Access Compliance Report

Public Rights-of-Way (Curb Ramps)

Intersection ID: 53631	Main Street: PROVIDENCE_RD_WEST	Cross Street: BEACON_VALLEY_ST	Location: SE
ADA ID: FC26771B15AC	Ramp Type: Perp	Initial Pass/Fail: Fail	Overall Compliance: No
Codes/Mitigation Info/Possible Solution		Field Measurements/Component Compliance	
Severity Score: 21.25

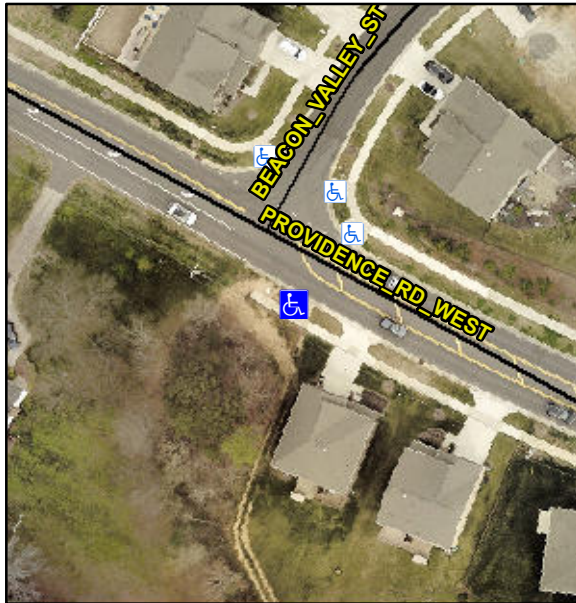
Not Found, R304.5.1, R304.2.2

Compliance	Description	Data	Compliance	Description	Data
N/A	Ramp Length (in)	97.0	No	Ramp Slope (%)	8.7
No	Ramp Width (in)	47.0	Yes	Ramp XSlope (%)	0.5
N/A	Flare Type LT	N/A	N/A	Flare Type RT	N/A
N/A	Flare Slope LT (%)	N/A	N/A	Flare Slope RT (%)	N/A
N/A	Flare Traversable LT?	N/A	N/A	Flare Traversable RT?	N/A
N/A	Landing Length (in)	N/A	N/A	DWS Provided?	N/A
N/A	Landing Width (in)	N/A	N/A	DWS Contrast?	N/A
N/A	Landing Slope (%)	N/A	N/A	DWS Length (in)	N/A
N/A	Landing X Slope (%)	N/A	N/A	DWS Full Width?	N/A
N/A	Landing Curb? (Y/N)	N/A	N/A	DWS Offset (in)	N/A
N/A	Shared Landing?	N/A			
N/A	Gutter Ponding?	N/A	N/A	Gutter Slope (%)	N/A
N/A	Gutter Lip Ht (in)	N/A	N/A	Gutter X Slope (%)	N/A
N/A	Painted X Walk1?	No	N/A	Painted X Walk2?	N/A
	X Walk 1 Direction	To NE		X Walk 2 Direction	N/A
N/A	X Walk 1 Width (in)	N/A	N/A	X Walk 2 Width (in)	N/A
	X Walk 1 Slope (%)	0.6		X Walk 2 Slope (%)	N/A
	X Walk 1 X Slope (%)	0.8		X Walk 2 X Slope (%)	N/A

Remove & Replace Entire Ramp.
